STAFF REPORT ACTION REQUIRED

65 Wicksteed Avenue, Unit F Sign Variance Request

Date:	March 14, 2008
То:	Chairman and Members, North York Community Council
From:	Director of Building and Deputy Chief Building Official
Wards:	Ward 26 – Don Valley West
Reference Number:	File No. 2008 NY 005 08 106232 ZSV 00 ZR

Attachment 4 - Sign Details Signs A & Sign B

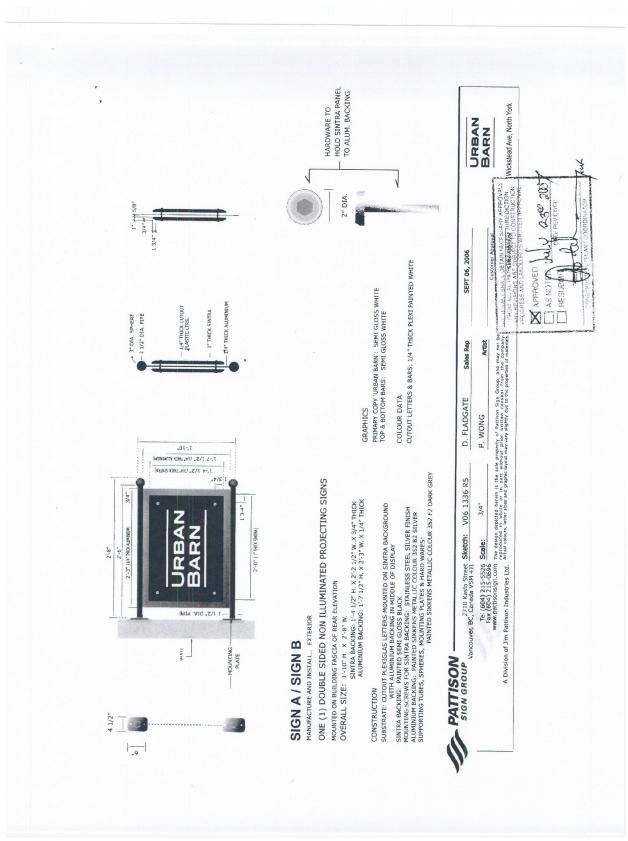
The applicant is proposing a total of three square illuminated projecting facial wall signs for business identification. Projecting signs are not permitted at this location.

Two of the signs (A and B) are proposed on the south wall facing the parking area, and will have an area of .55 m^2 , a height of .54m and a projection of .8m.

- 1. The request for variances be approved; and
- 2. The applicant be advised on approval of the variances of the requirement to obtain the required permits.

Attachment 5 - South Elevation (Sign A and Sign B)

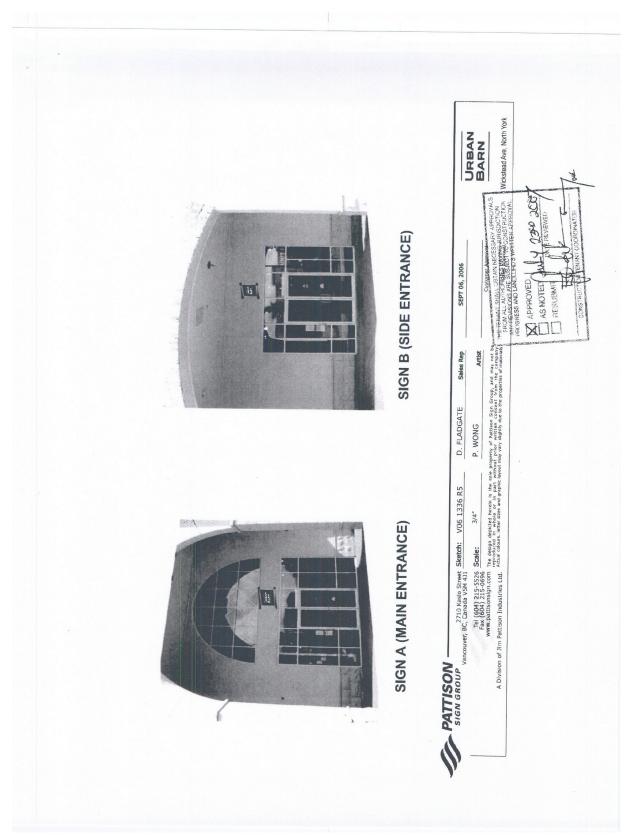
Currently, the business has no identification on the wall facing Wicksteed Avenue, Signs "A and B" would provide advertising to the passing motorists while "Sign C" is intended to be seen by the pedestrian traffic passing under the building's large overhead enclosures.

Attachment 6- North Elevation (Sign C)

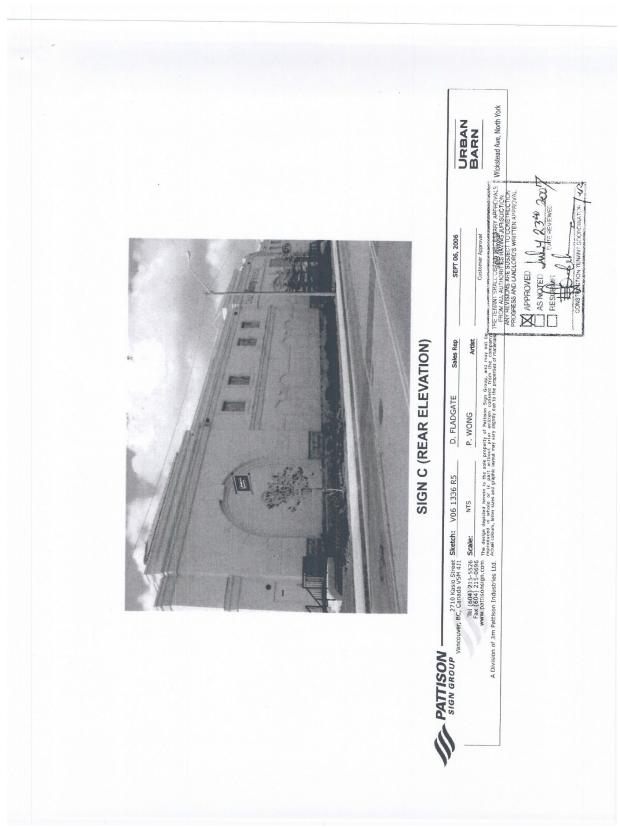
The third sign (C) is proposed on the north wall facing Wicksteed Avenue and will have a sign area of $.55 \text{ m}^2$, a sign height of 0.54m and a projection of 1.3m.
